**Passenger Equipment Safety Standards;
Final Rule**

[FRA Docket No. PCSS-1, Notice No. 7]

ACTION: Final rule; response to petitions for reconsideration.

SUMMARY: This document responds to certain of the petitions for reconsideration of FRA's May 12, 1999 final rule establishing comprehensive Federal safety standards for railroad passenger equipment. This document clarifies and amends the final rule.

Figure 2

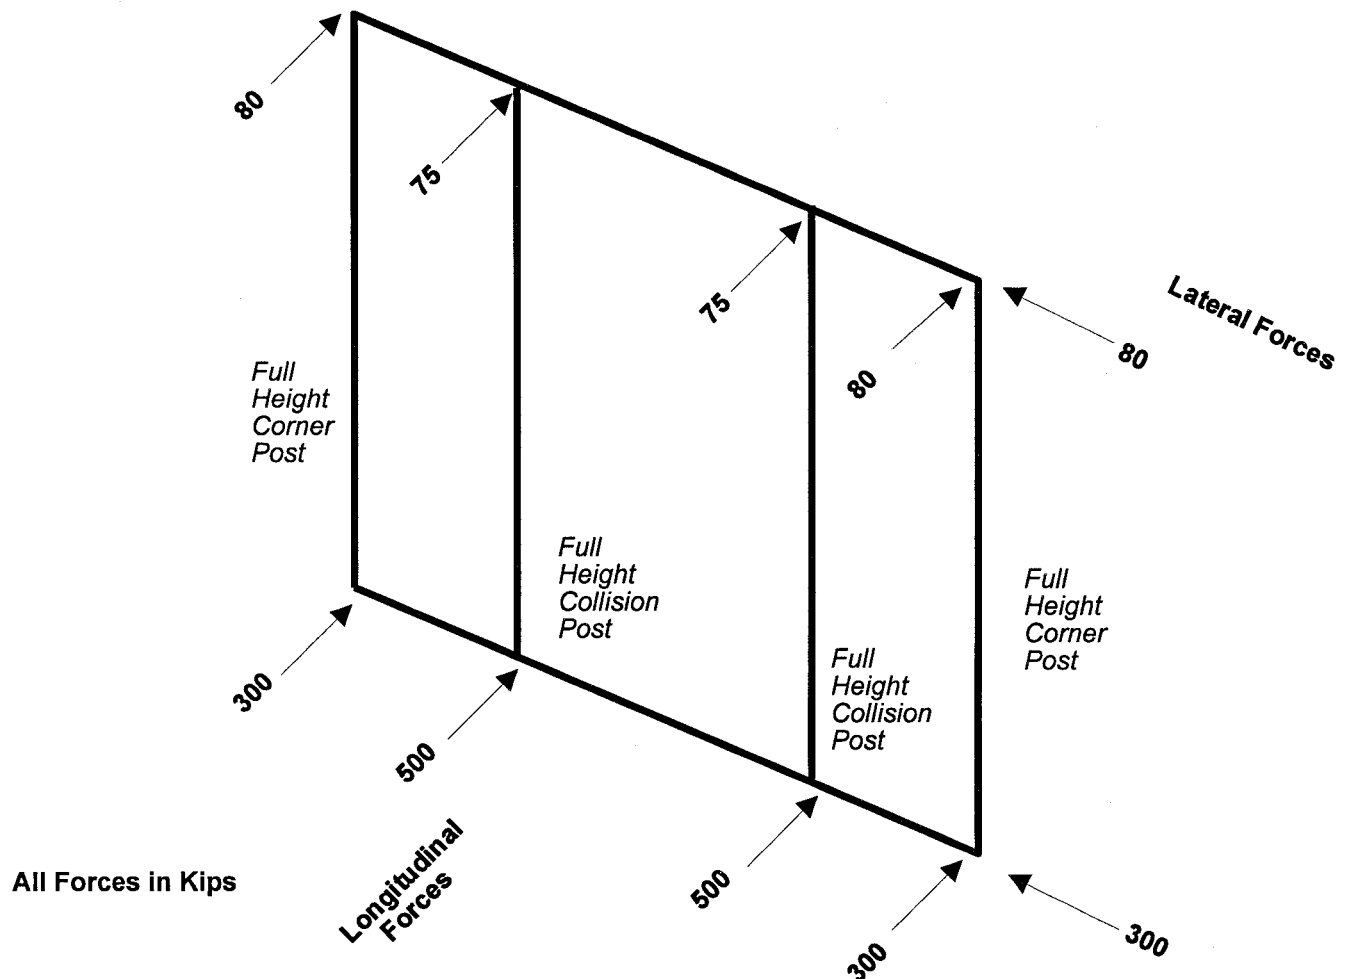
FRA has adopted Bombardier's request and modified paragraph (b)(1) accordingly. (FRA has also made a

corresponding change to figure 2 to subpart E.) FRA recognizes that the strength of the power car cab's rear collision posts should not necessarily be dependent on the strength of the cab's front end structure, as the front and rear end structures are intended to protect against somewhat different hazards. The front end structure must protect against the greater hazard of a head-on collision with another train or object.

30. Figure 2 to subpart E is revised to read as follows:
